# BCA Assessment Report

805-817 Mamre Road, Kemps Creek

**Revision 6**

20 November, 2024

Figure 2 – Perimeter Vehicular Access Non-Compliances

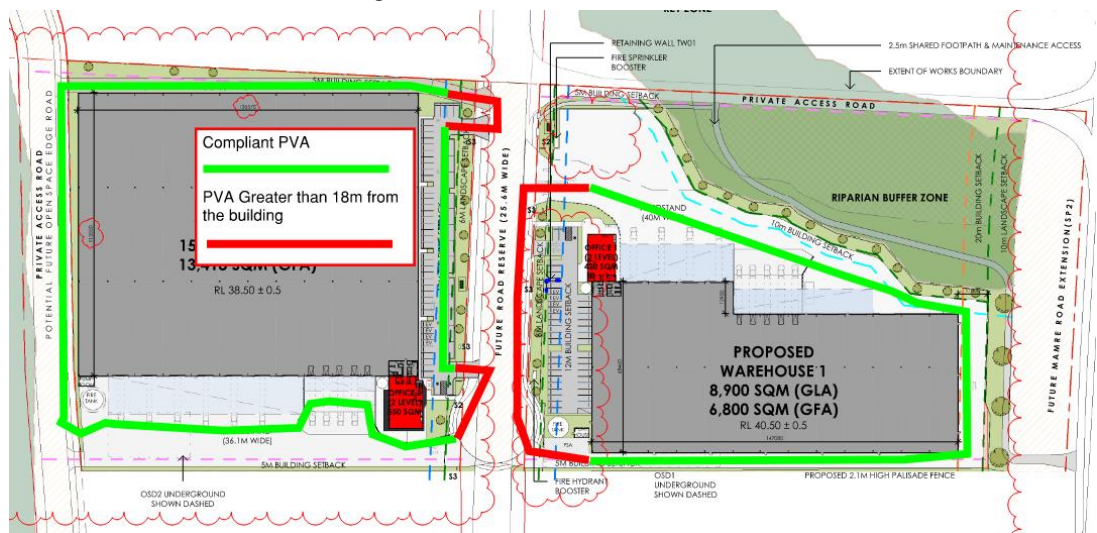
**Comment:** Both warehouses do not comply with the provisions of C3D5 and thus the following non-compliances are to be addressed as a Performance Solution by the fire engineer to demonstrate compliance with Performance Requirement CP9.

- + Warehouse 1 and 2 do not allow for a perimeter vehicular accessway within 18m of the external walls of each building in the locations shown below:
